City of Alexandria, Virginia

MEMORANDUM

SUBJECT: 277 SOUTH WASHINGTON STREET, BAR CASE #2012-0198

EAGLEBANK: ALEXANDRIA
 277 S. WASHINGTON ST.
 ALEXANDRIA, VA 22314
TENANT BUILD-OUT

1
A4 **WASHINGTON ST. ELEVATION: EXISTING**
SCALE: 3/16" = 1'-0"

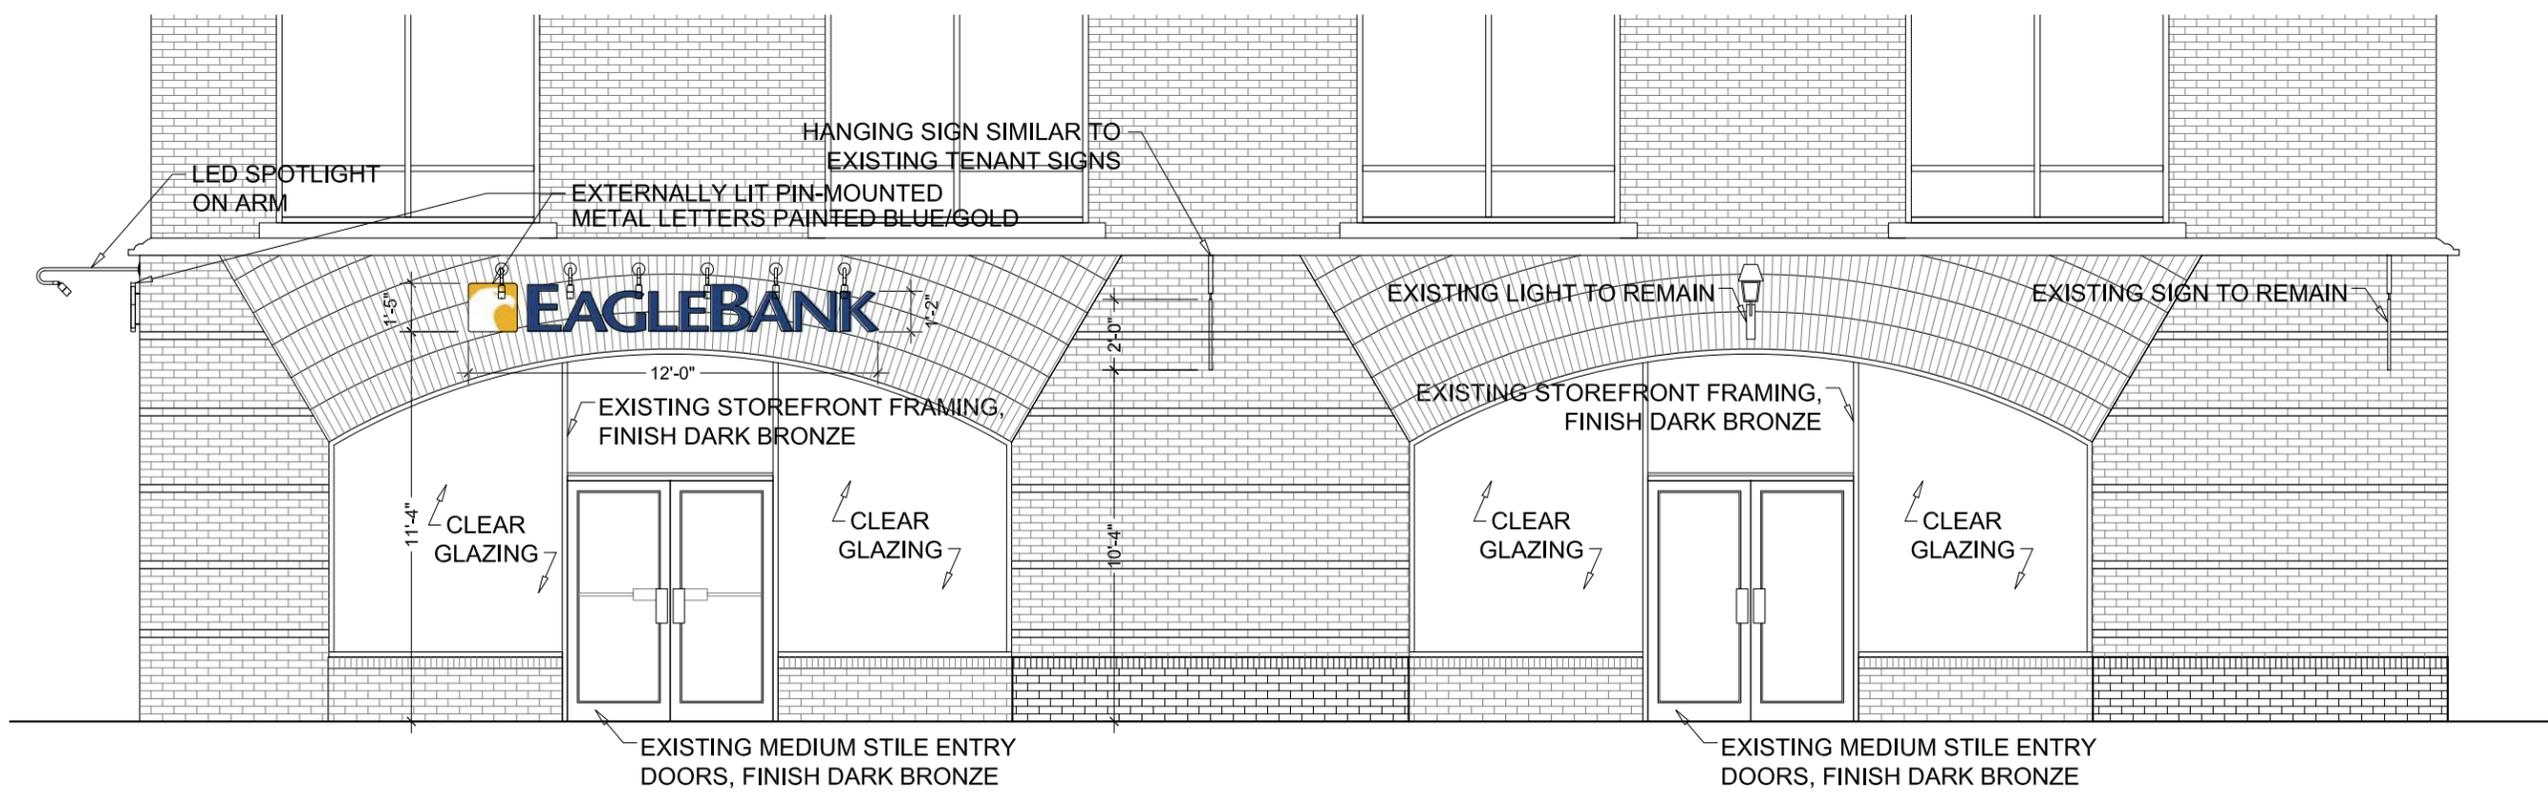
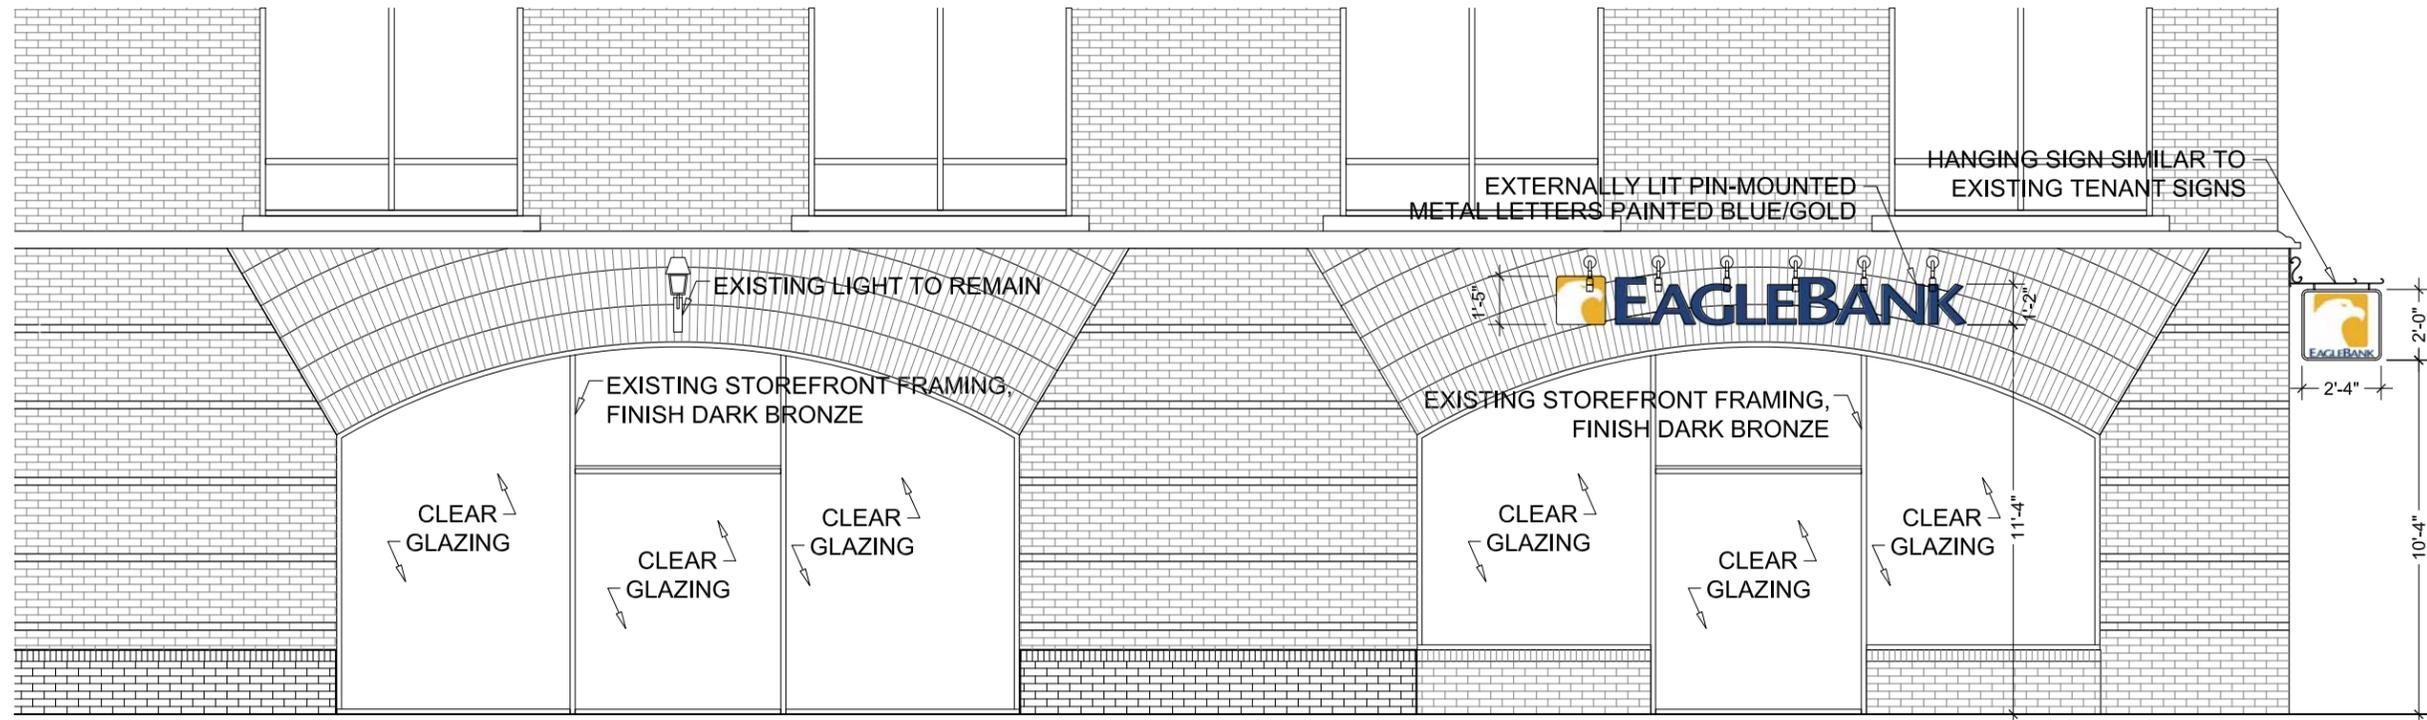
Dr. Fitzgerald expressed concern about the location of the ATM on Washington Street. He suggested that the ATM would be more appropriate if it was located on the Duke Street elevation.

Mr. Smeallie stated that he agreed with the comments made by the National Park Service regarding the location of the ATM and the use of halo-lit signage on the Parkway.

Mr. von Senden shared other Board members concerns with the proposed location of the ATM. He suggested that a design solution could be developed for the Duke Street elevation which incorporated lighting and a brick walkway.

Our comment on this project is that given one of our main goals is to clear Washington Street of visual clutter - has the applicant examined moving the ATM and other improvements to the second doorway on the right of the entrance over to the Duke Street side of the building? We're aware that the building is modern, but keeping the four archway entrances along the Washington Street side more uniform would certainly decrease the visual clutter

After the Board's deferral, the applicant responded to the Board's comments with a revised submission. The applicant remains concerned about relocating the ATM to the Duke Street elevation for safety reasons. Instead, the applicant proposes to maintain the existing paired doors and create an ATM vestibule. The applicant has eliminated the halo illumination and instead proposes to use targeted mini spotlights on the channel letters. The applicant has added a hanging sign on the South Washington Street elevation, which will measure approximately two feet by two feet four inches (4.67 square feet) and include the eagle motif and reads "EagleBank."

Staff supports the proposed revisions. The relocation of the ATM to a vestibule is a preferred alternative and, because it will be located more than four feet on the interior, the ATM and related signage on the interior do not require BAR review. Therefore, the ATM has been removed from the application. While Staff supported the originally proposed halo illumination, the use of targeted mini spotlights is appropriate on this building and a type of lighting that Staff can administratively approve for signage that can be administratively approved. The addition of the hanging sign relates to the business located to the north, Society Fair, and contributes to the pedestrian scale of this block.

1
A5 **DUKE ST. ELEVATION: PROPOSED**
SCALE: 3/16" = 1'-0"

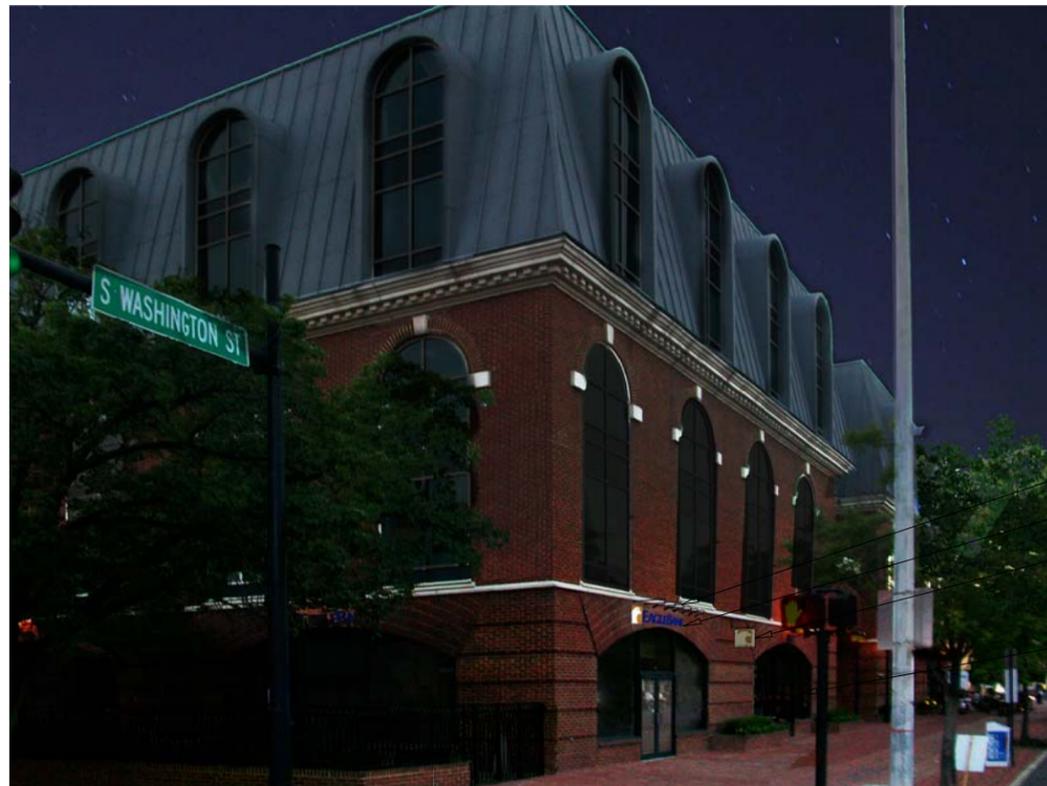
At the July 11, 2012 hearing the Board deferred the application for signage and alterations for an ATM, requesting that the applicant return with a more appropriate proposal that included the relocation of the proposed ATM to the Duke Street elevation and external illumination for the signage rather than halo illumination.

- LED SPOTLIGHTS
- PIN-MOUNTED METAL LETTERS
- HANGING SIGN SIMILAR TO OTHER TENANTS
- ATM RELOCATED TO VESTIBULE

2
A4 **EXTERIOR ELEVATION: PROPOSED**
SCALE: 3/16" = 1'-0"

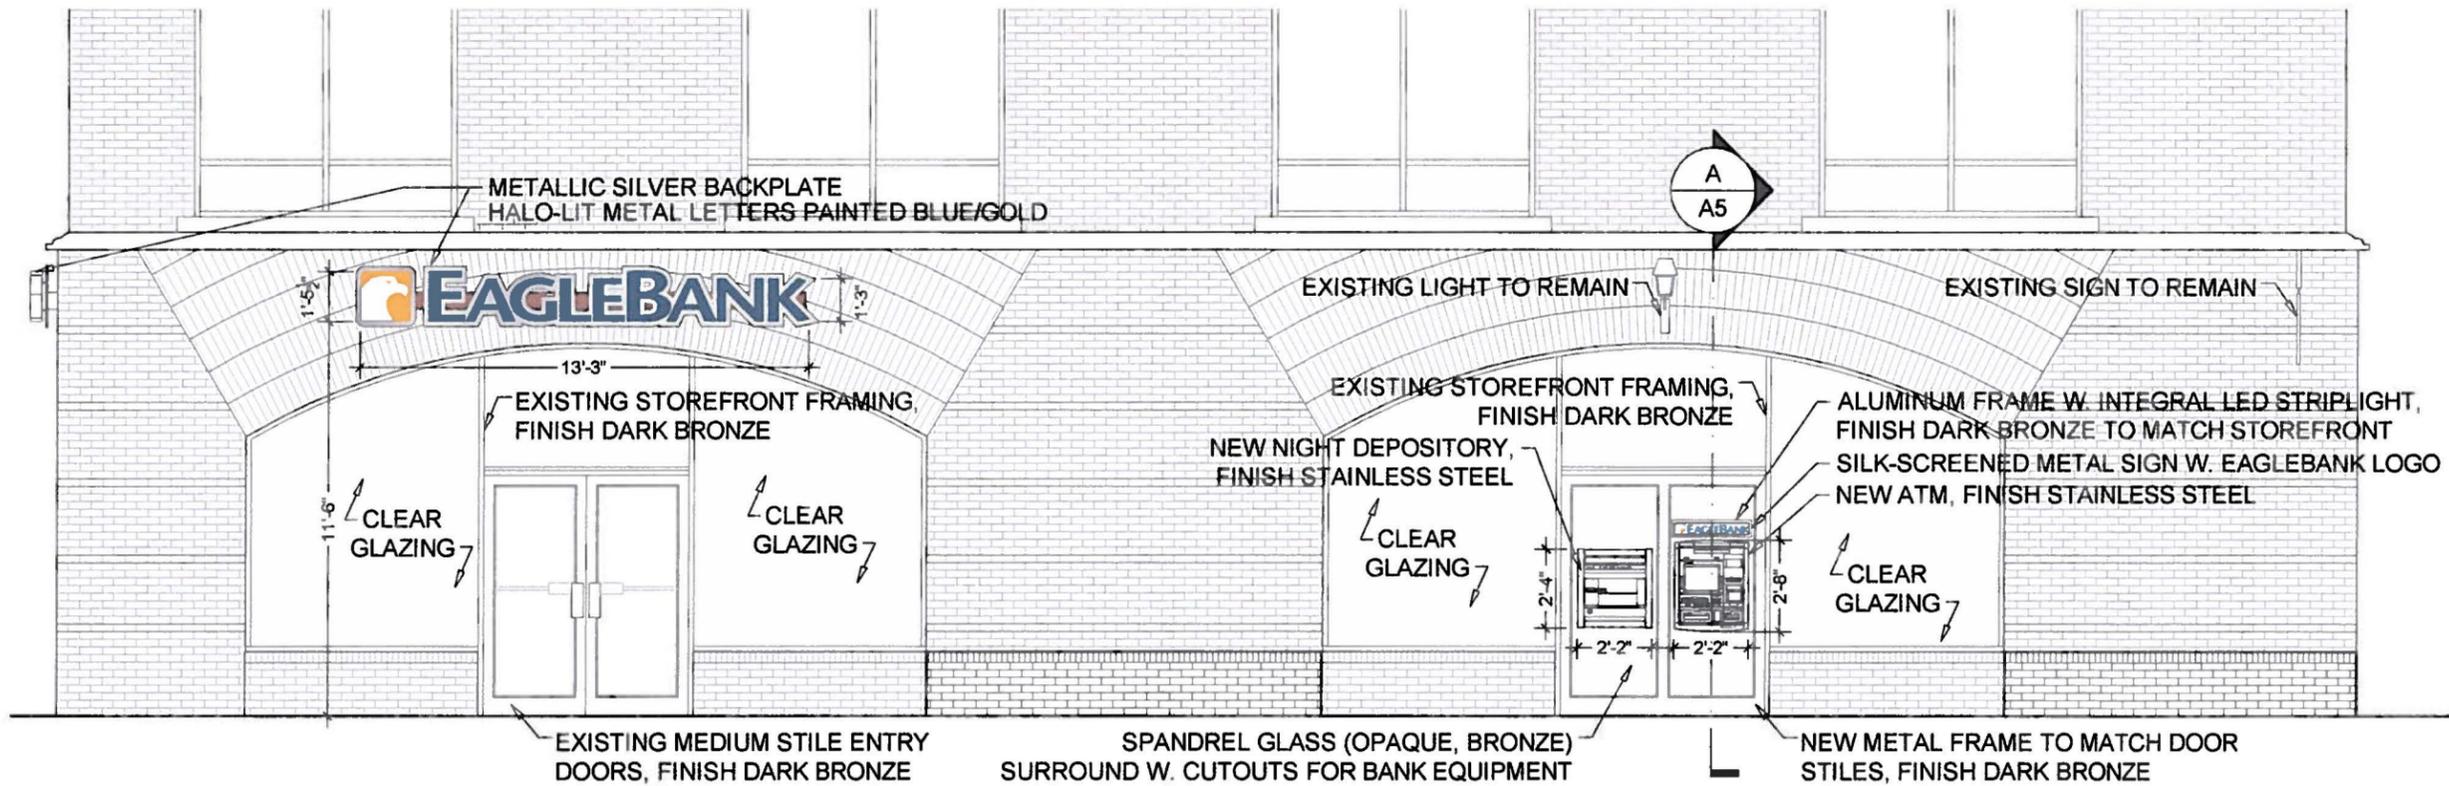
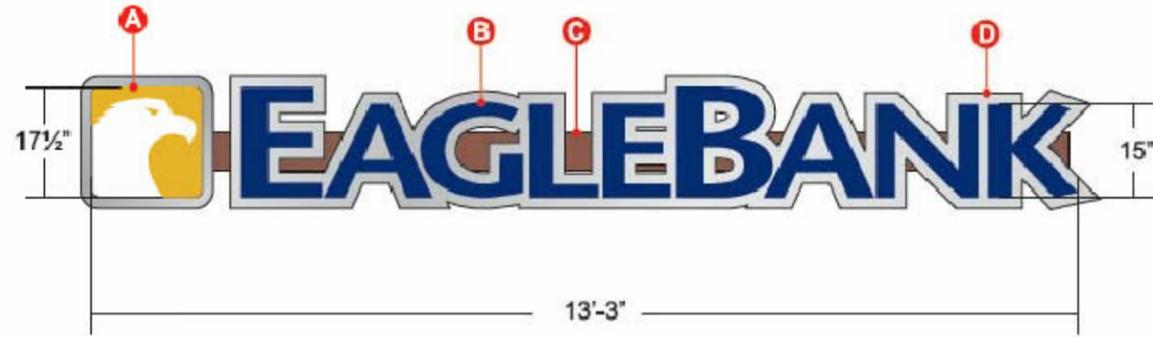
However, with respect to the proposed back plate, off of which the halo illumination will reflect, Staff is concerned with the architectural character of the reflectivity of the proposed metallic silver finish on the back plate. The BAR had expressed similar concerns while reviewing the recent Burke & Herbert Bank signs and these concerns were later muted by the applicant. Staff can support the use of a back plate but only if it has a neutral color with a matte finish and if the LED lighting level is approved by Staff in the field using a sign mock-up or on the installed signs using dimmers, as is the Board's standard condition for this new lighting technology.

It is important to note that the National Park Service reviewed this application and recommended that the applicant examine moving the ATM and other improvements to the second doorway on the right of the entrance over to the Duke Street side of the building. NPS suggests keeping the four archway entrances along the Washington Street side more uniform to decrease the visual clutter.

1. That the proposed back plate not be a reflective silver and have a matte finish instead.
2. That the LED light strip for both the ATM and the wall signs be installed with dimmers with final illumination level to be approved by Staff in the field.

1
A7 SECTION @ ATM: PROPOSED
SCALE: 1" = 1'-0"

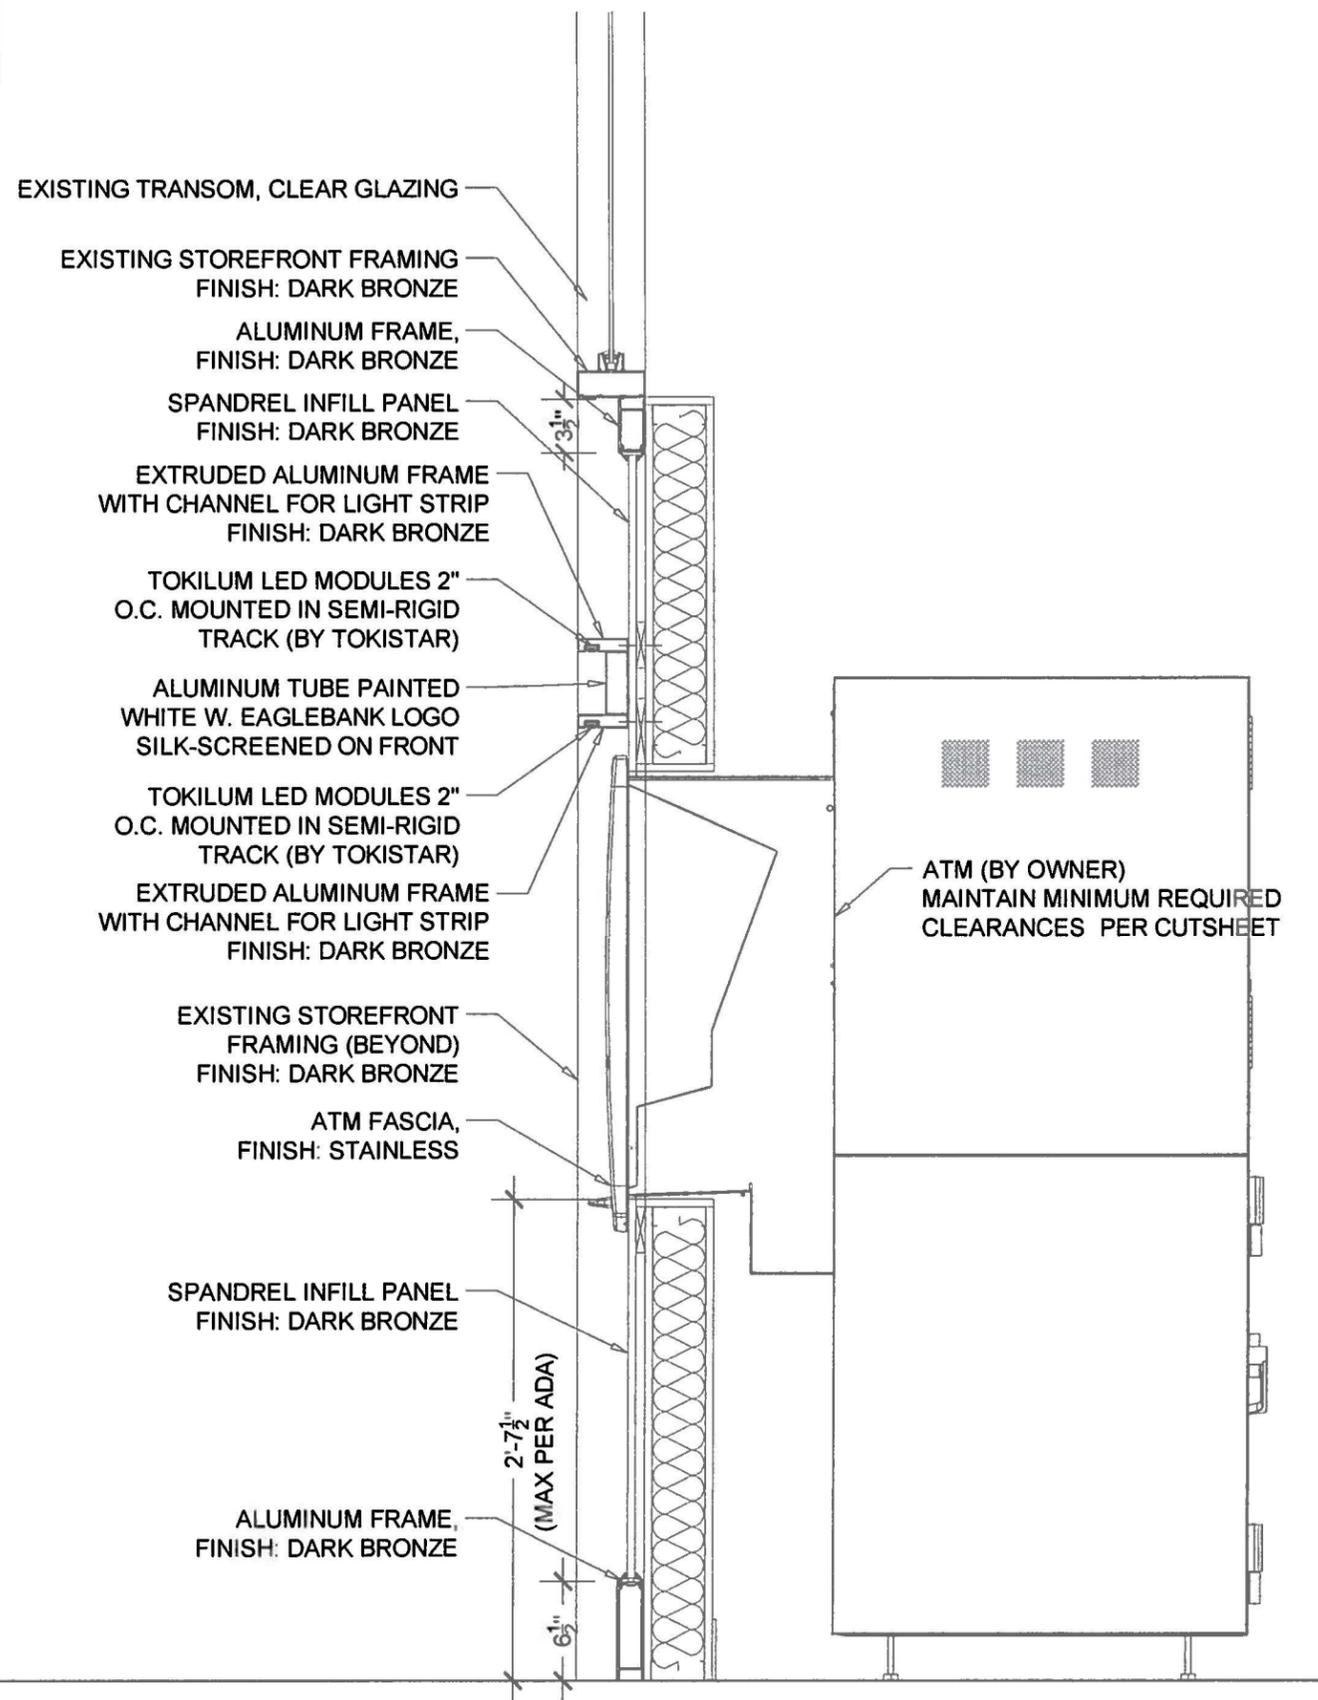
Mr. Keleher had questions regarding the ATM's backplate material and agreed with the staff recommendation to utilize a matte finish.

above the ATM is appropriate with respect to size and Zoning Ordinance requirements. In order to minimize excessive illumination, Staff recommends that the LED strip lighting at the ATM be installed with an adjustable dimmer and that the final approval of lighting levels be determined in the field.
